**Addendum No. 1**  
**February 17, 2025**

Project: Lincoln High School Auditorium Renovation  
Sioux Falls, South Dakota  
Project #3021

Architect: Architecture Incorporated

LEVEL 01 - THEATRICAL LIGHTING PLAN

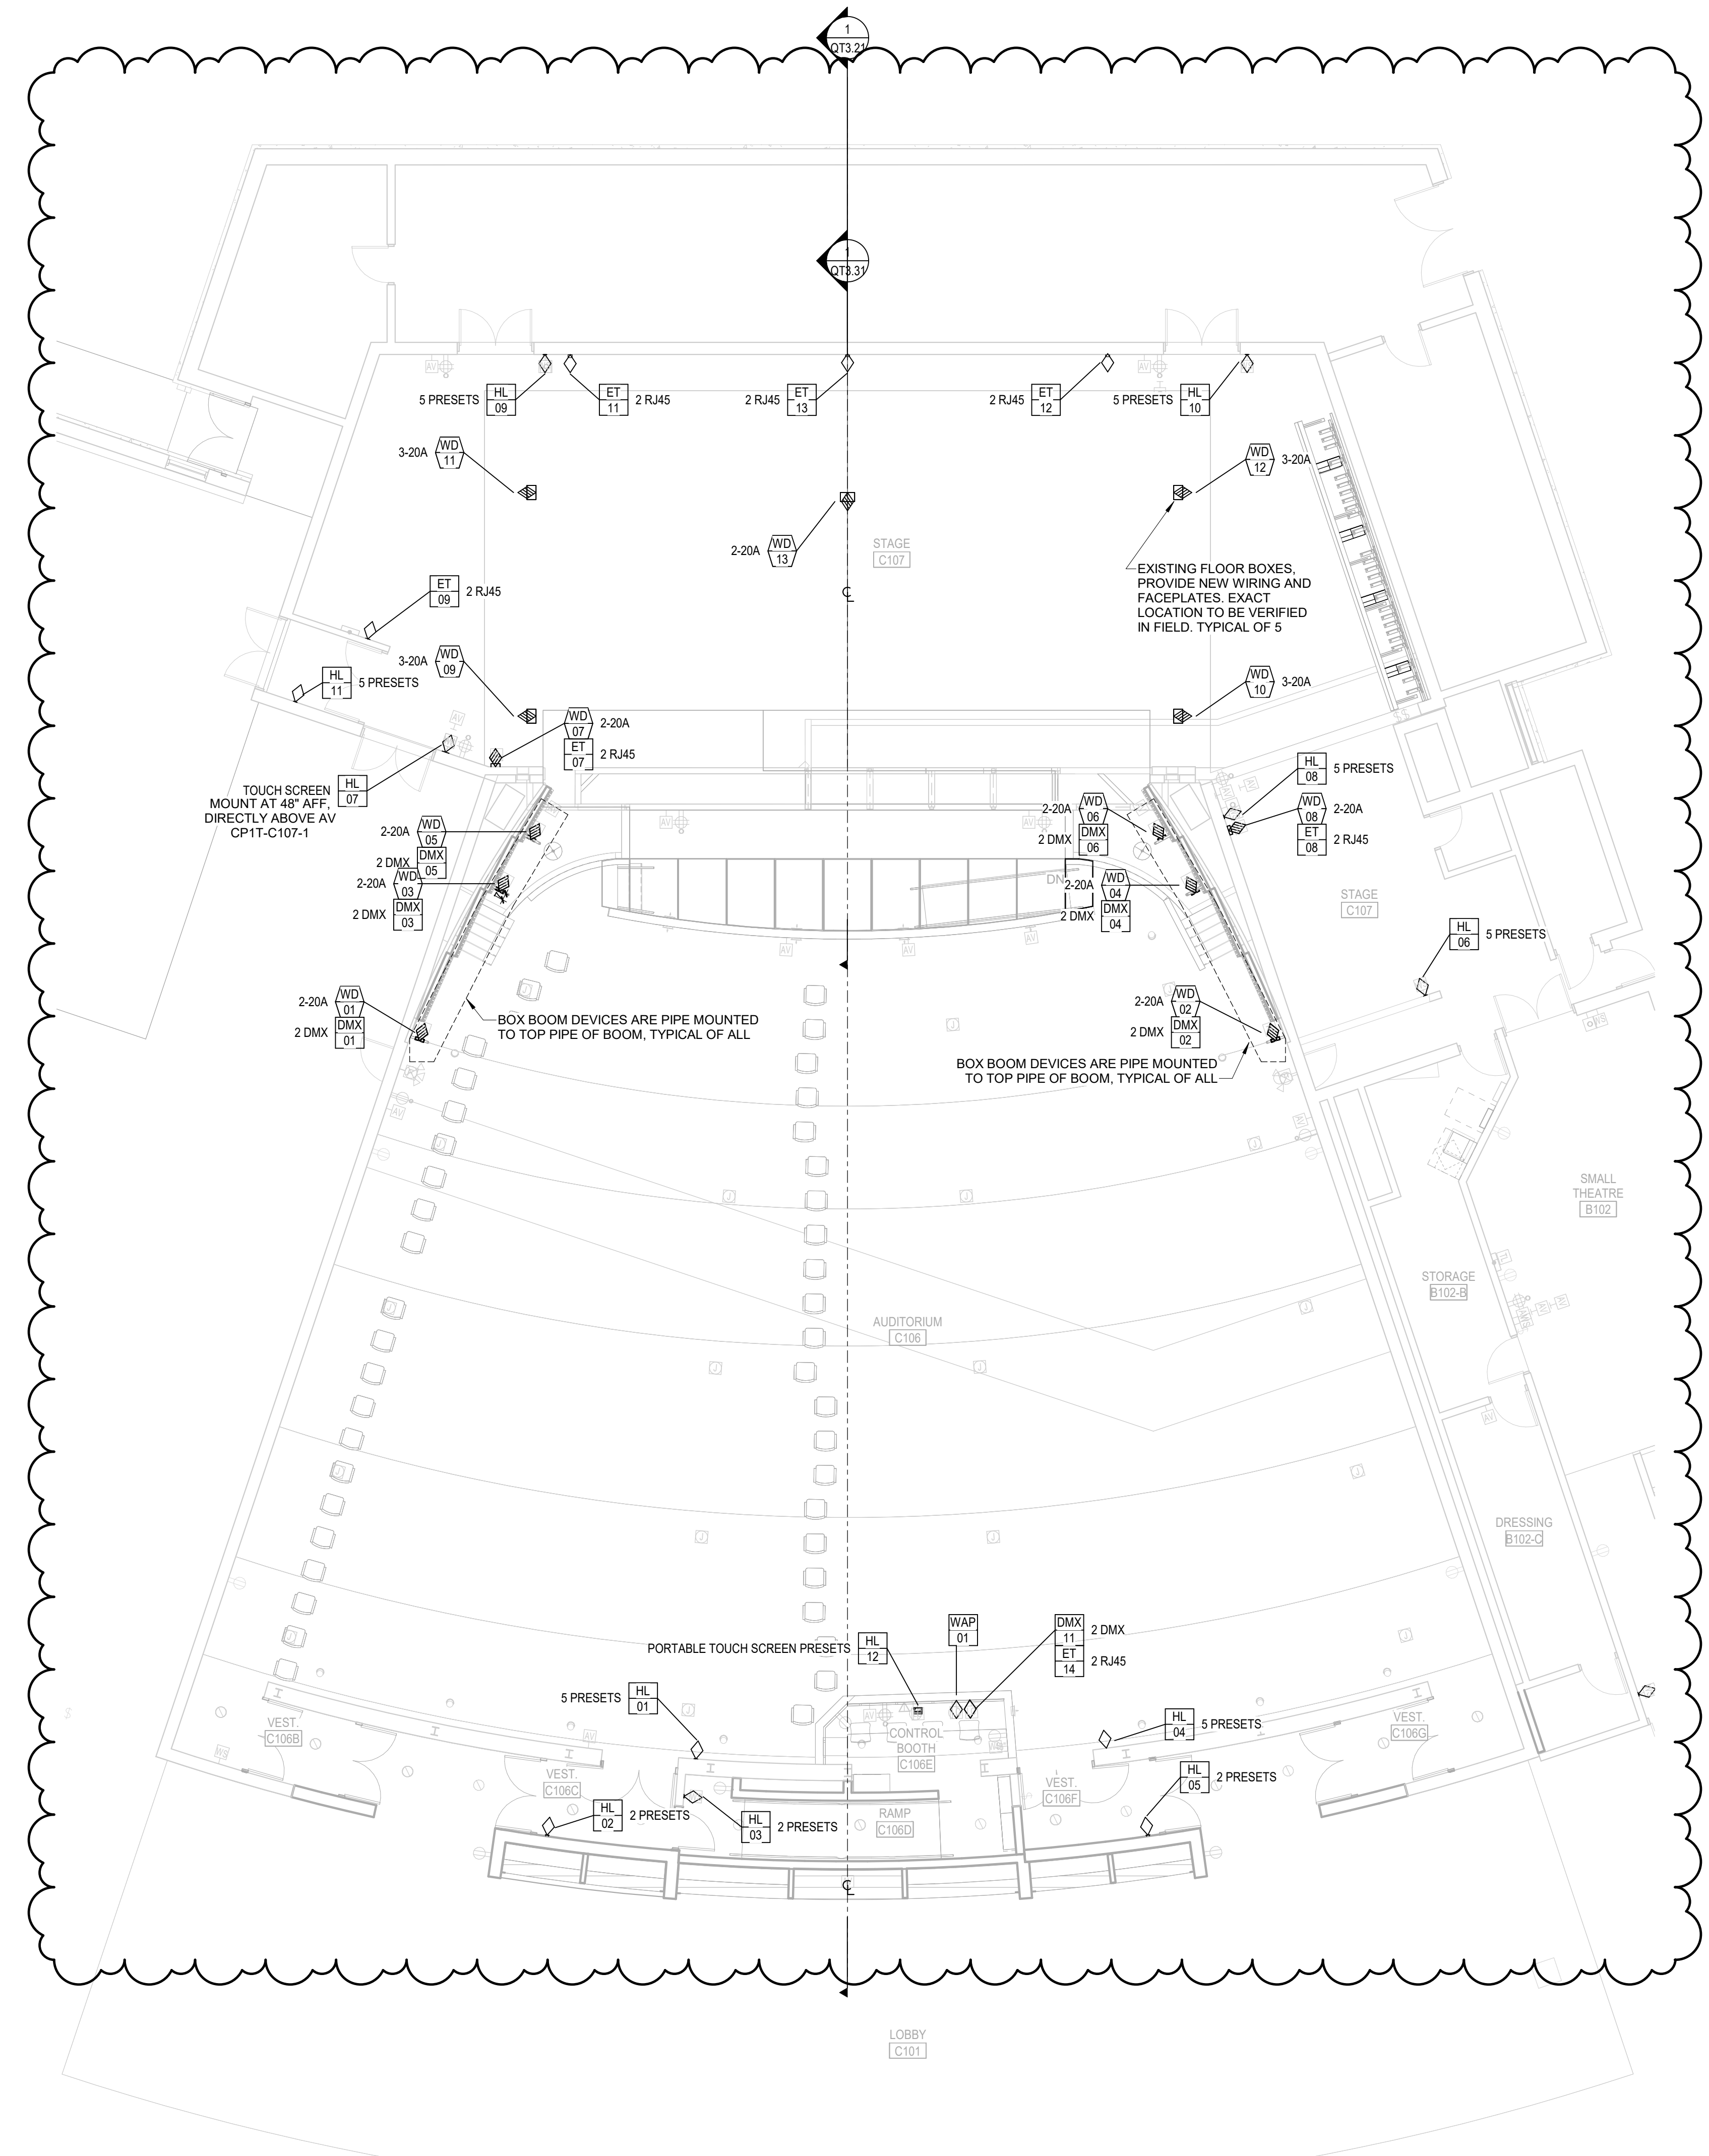
- 3) SHEET QT1.01 – THEATRICAL LIGHTING PLAN, AUDITORIUM LEVEL 1
  - a. Revise plan "LEVEL 01 - THEATRICAL LIGHTING PLAN" per attached sheet.
    1. Revise HL device layout in all sound and light locks.
    2. Revise floor pocket devices on stage to power only.
    3. Delete device ET-10
    4. Replace devices ET-09, ET-11, ET-12, and ET-13 to be wall mounted devices. See plan for details.

**LEVEL 01 - THEATRICAL LIGHTING PLAN, LITTLE THEATRE**  
SCALE: 1/8" = 1'-0"

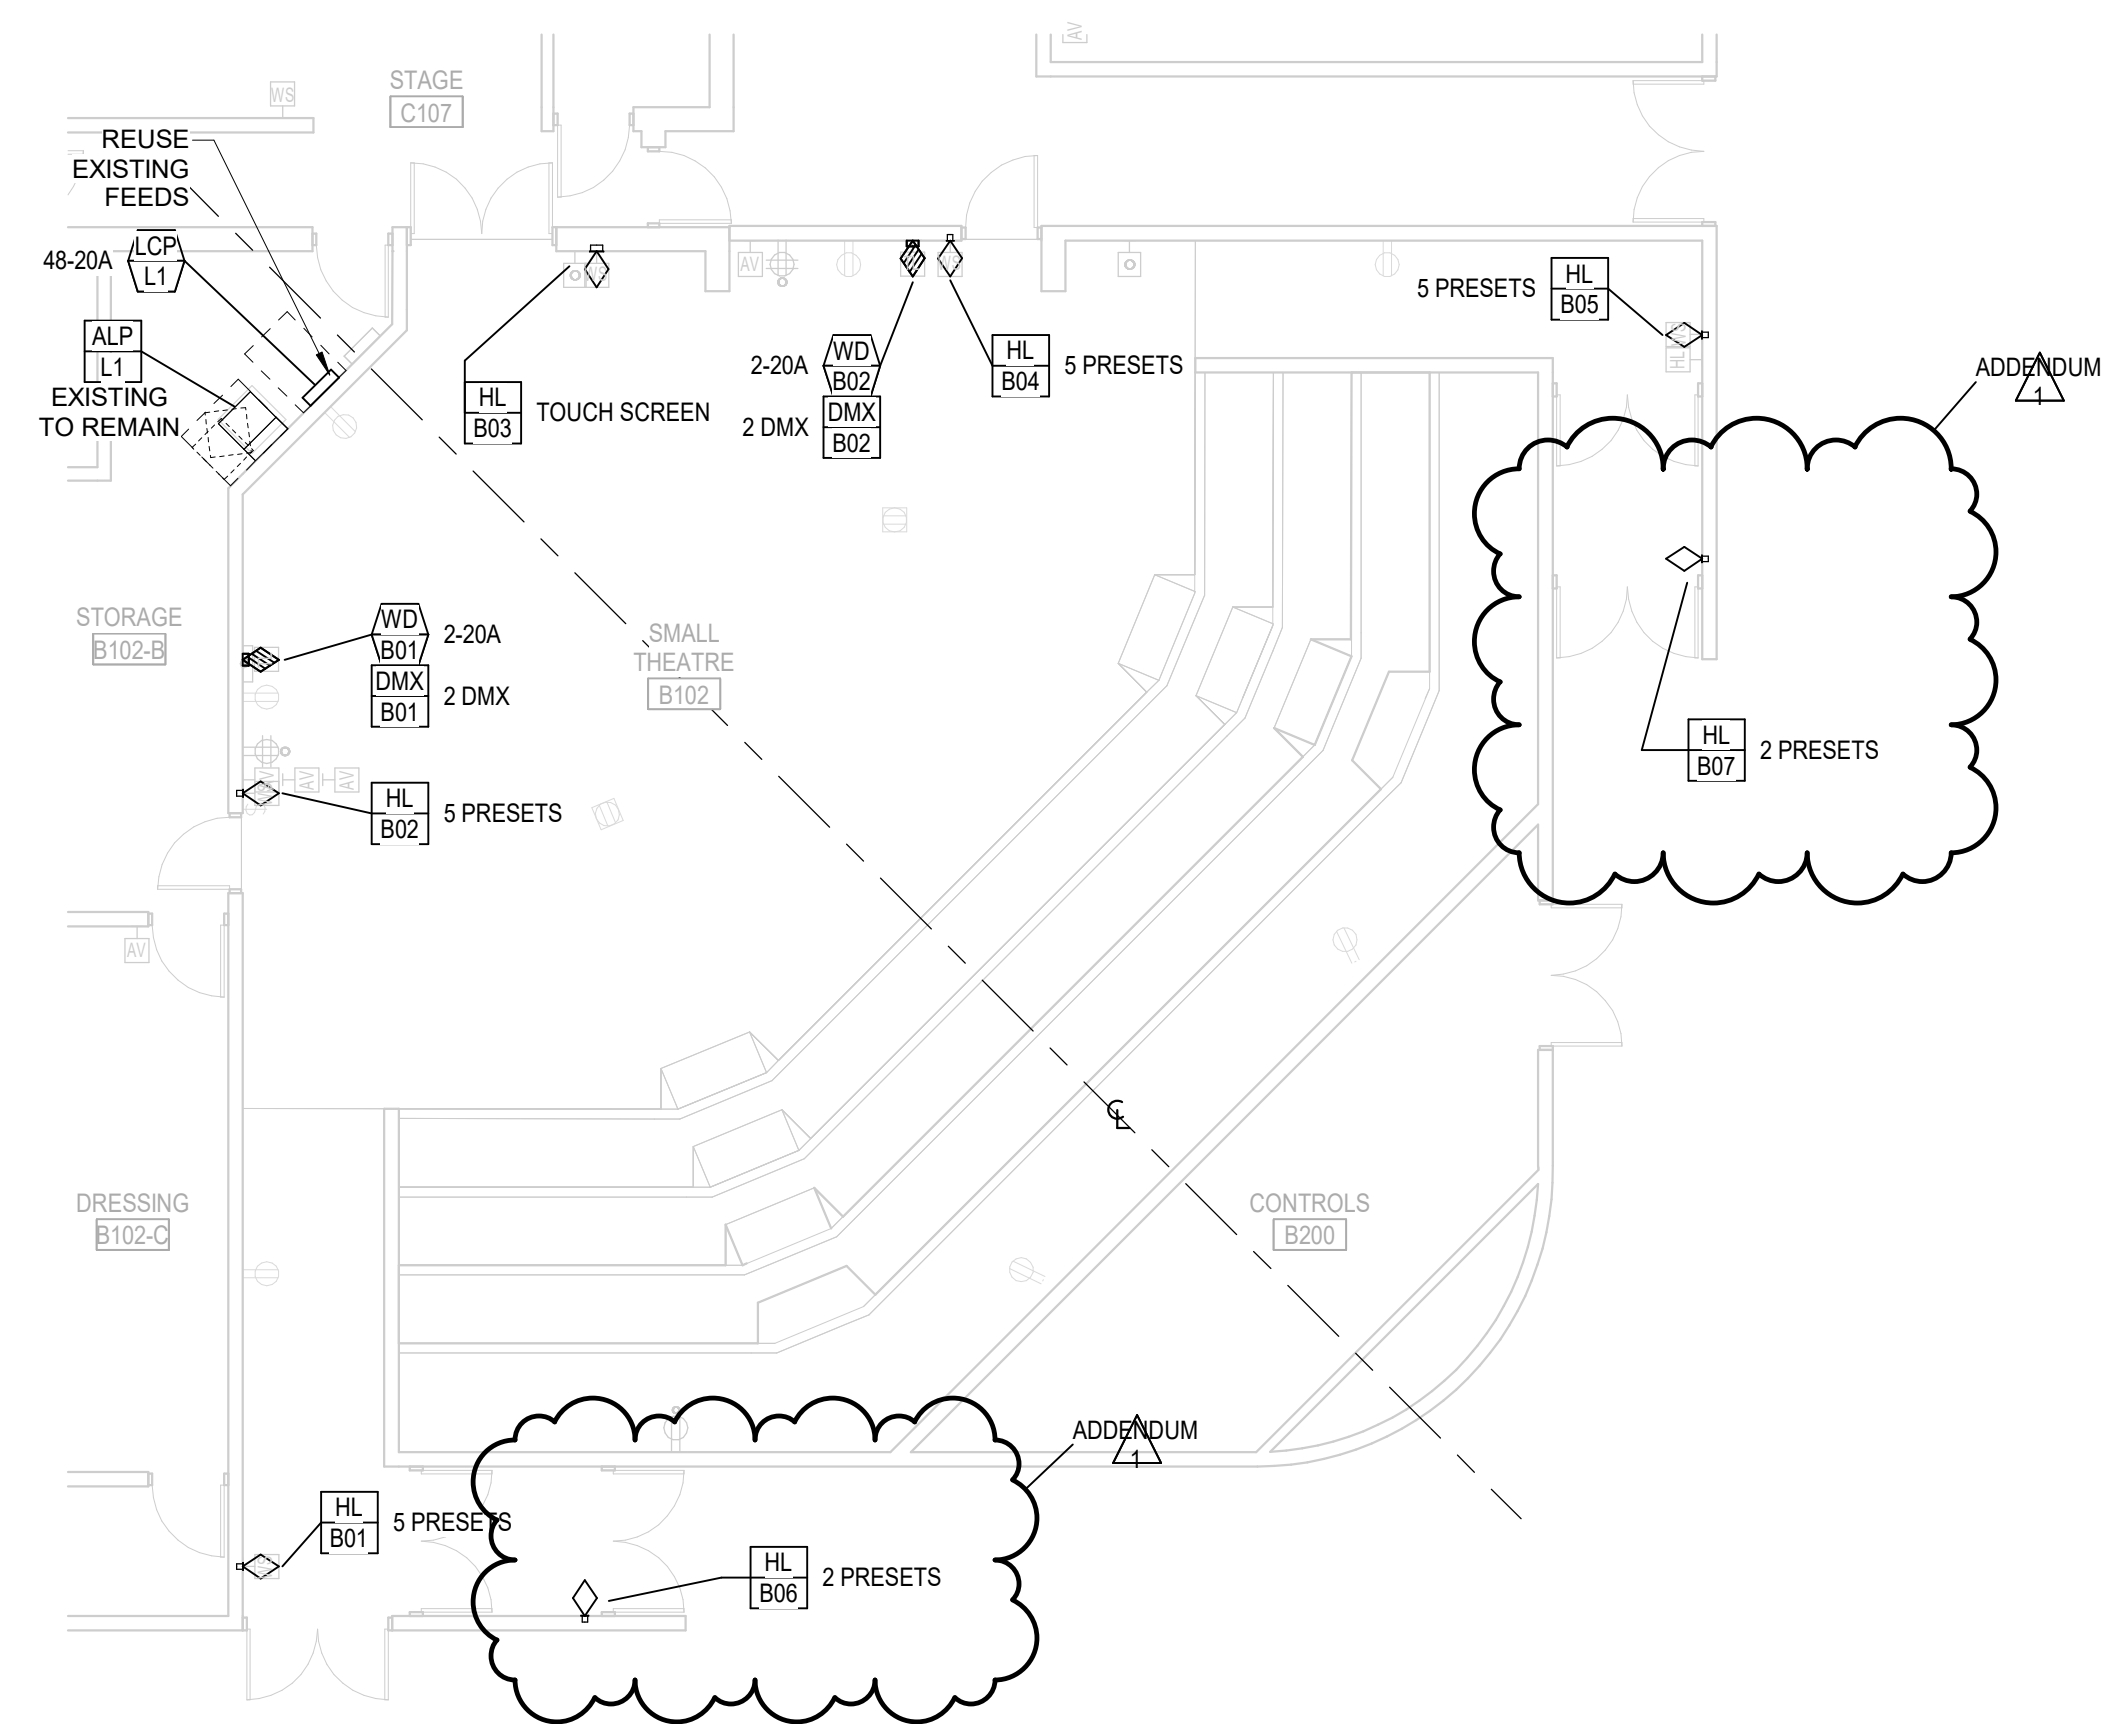
4) SHEET QT1.02 – THEATRICAL LIGHTING PLAN, LITTLE THEATRE LEVEL 1

- b. Revise HL device layouts in sound and light locks for the Little Theatre.
